U.S. Patent Application Serial No. 10/615,386
Amendment filed April 7, 2006
Reply to OA dated January 20, 2006

REMARKS

FIG. 4

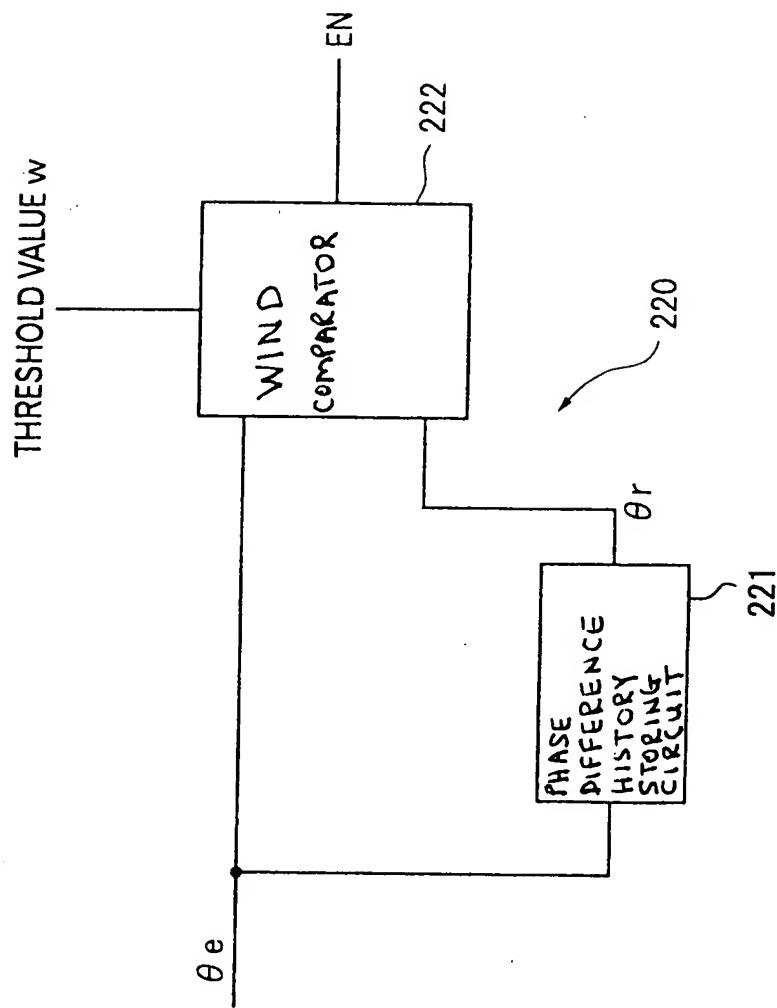
The drawings have been objected to for the reason set forth in item 3, page 2 of the outstanding Action. In amended Figures 3 and 4, submitted herewith, the block boxes have been labeled, as requested by the Examiner.

In Figures 3 and 4, the block boxes have been labeled, as requested by the Examiner.
